**PLANNING COMMISSION AGENDA**  
**JULY 18, 2019 – 6:30 P.M.**

**La Vista City Centre Theater Preliminary Plat**

## **Comment Response: Preliminary Plat-Final Plat Theater**

## **Comment Response: Preliminary Plat-Final Plat Replat 3**

PRELIMINARY SITE AND UTILITY PLAN	REV. NO.	DATE	REVISIONS DESCRIPTION	REVISIONS
LA VISTA CITY CENTRE REPLAT THREE LOTS 1 THRU 12	2019

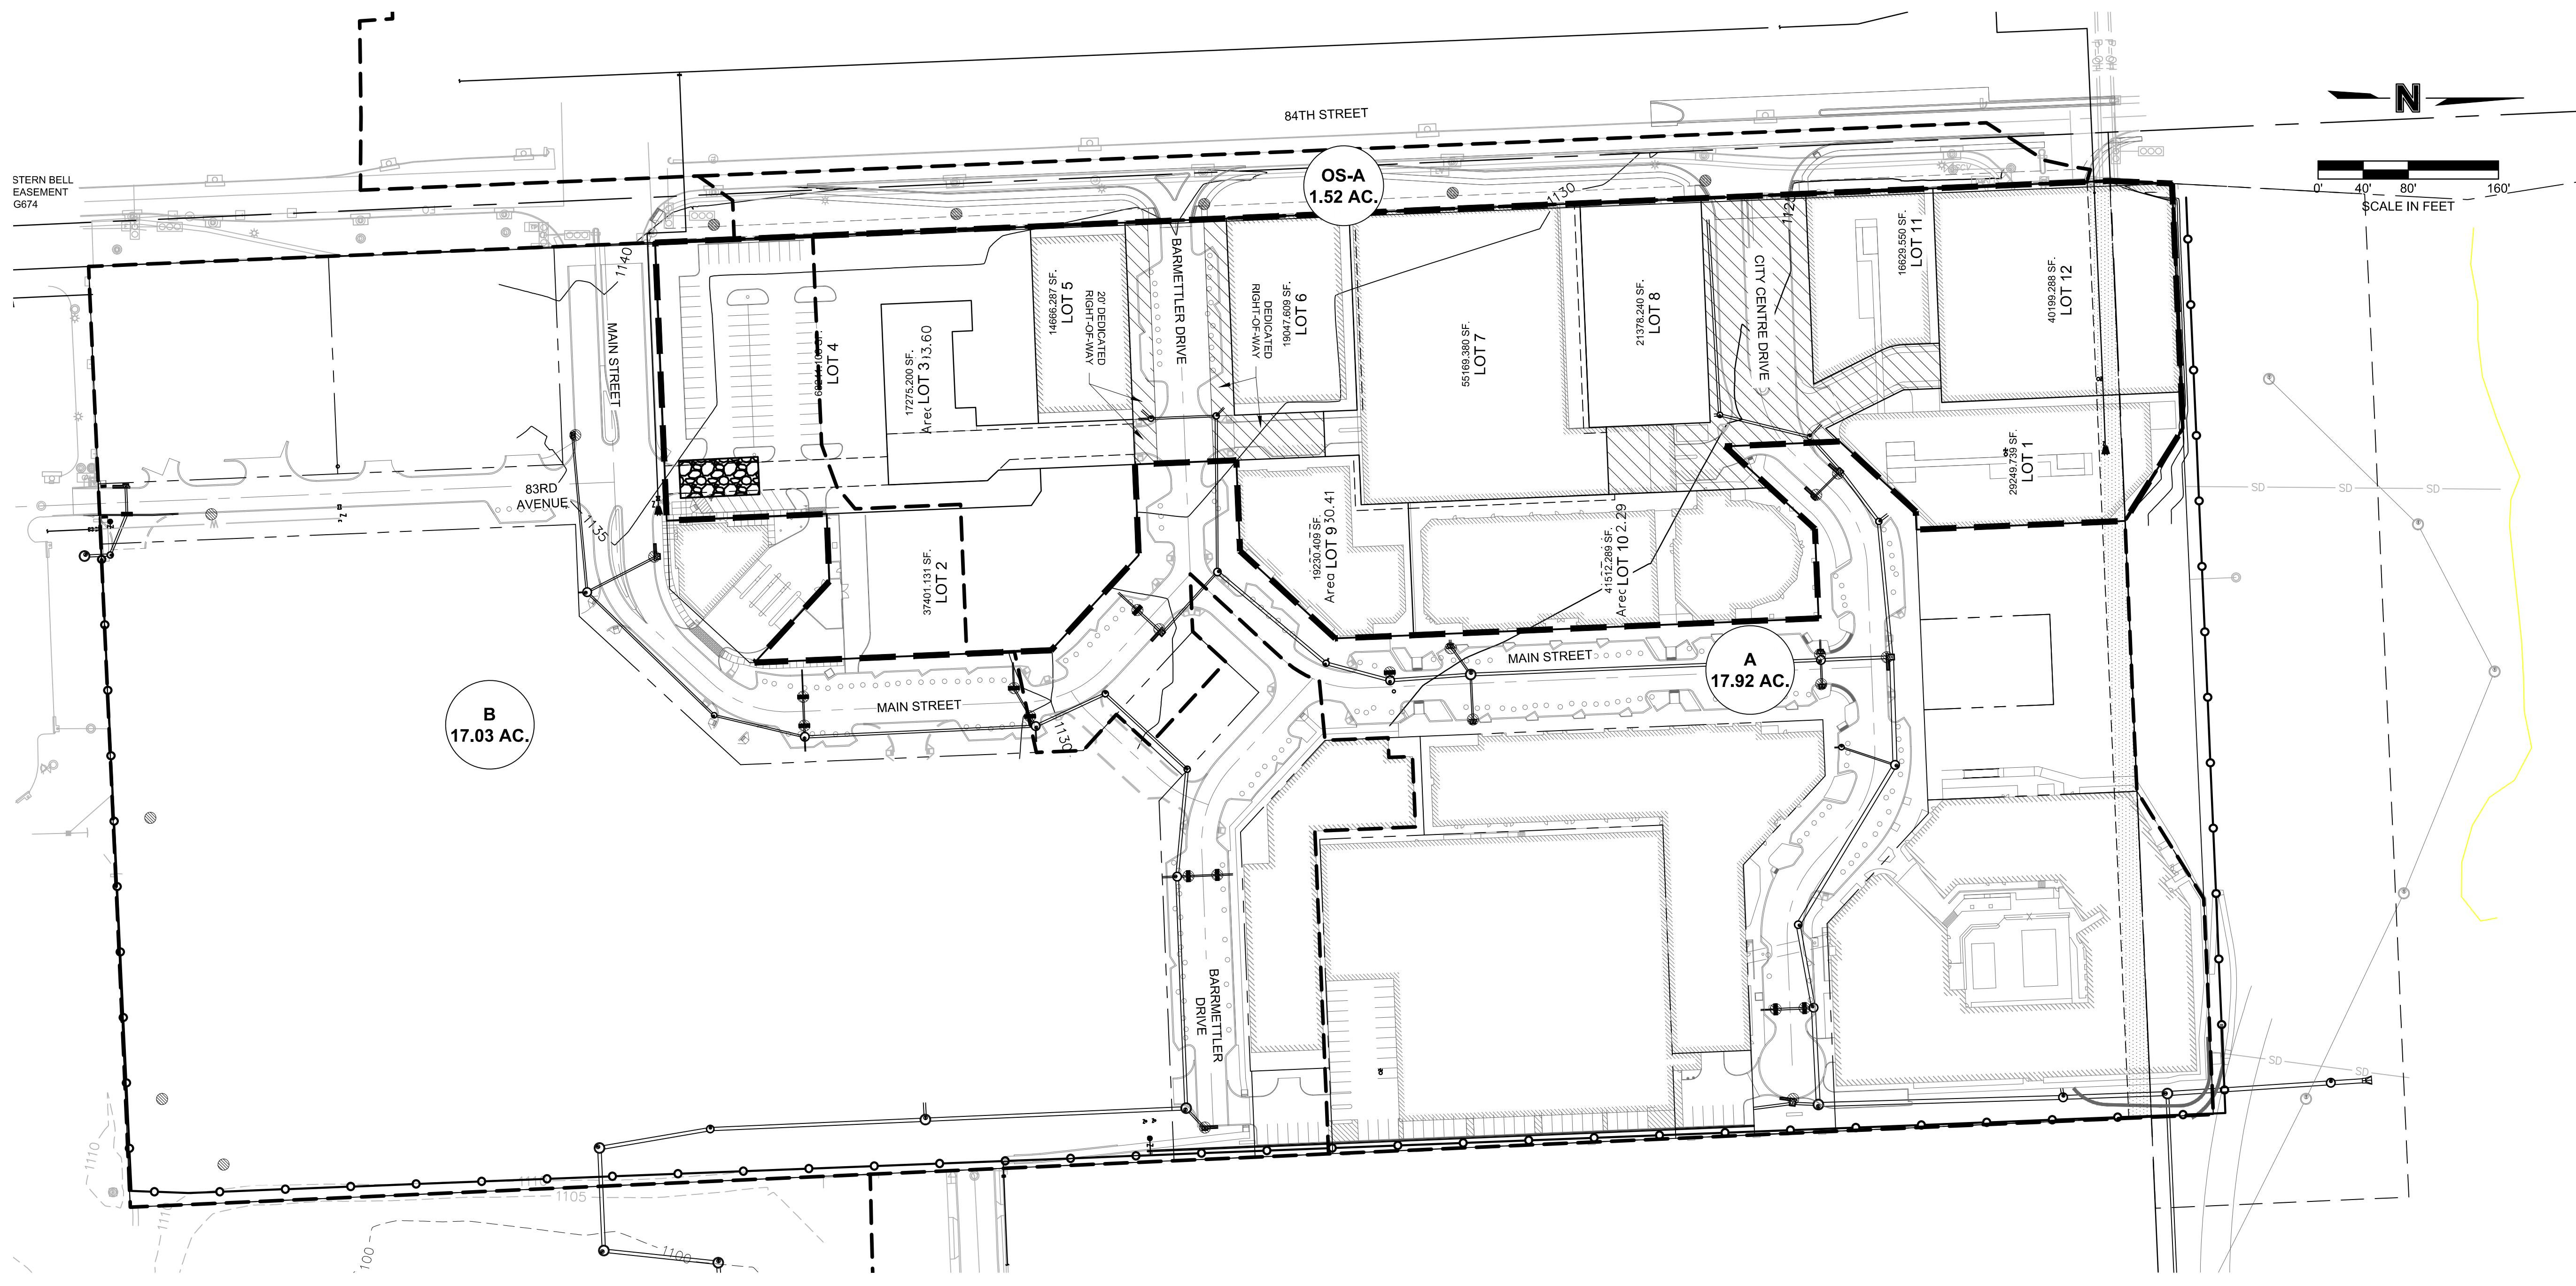
- a. The proposed sanitary sewer layout needs to address how Lots 1, 2, 3, and 8 will access sanitary sewer. The layout shown on C2.1 does not match the public infrastructure plans in some locations. **Response: The sanitary layout has been updated to ensure we are matching the public infrastructure layout. The stubs for the lots are shown for the lots.**

- b. A drainage plan is needed that identifies drainage areas and where they will connect to the infrastructure system. This pertains to Lots 1, 2, 5, 7 and 11 for example. **Response: The drainage for these lots are accommodated under the original drainage report for the overall development. Drainage for these lots are accommodated in the storm system running through the development and discharged to the north through the storm system.**

- c. Information on a PCSMP plan needs to be provided on Sheet C3.1. This would include reference to the current plan for PCSMP No. 20170324- 3736P and particularly Note 2 on Exhibit "8". Notations as to which lots will be expected to provide water quality devices in accordance with said Note 2 should be added to Sheet C3.1. **Response: Notes regarding the current PCSMP has been added. Reference to which lots are draining to specific pond and water quality areas per the original drainage report has been added to the plan.**
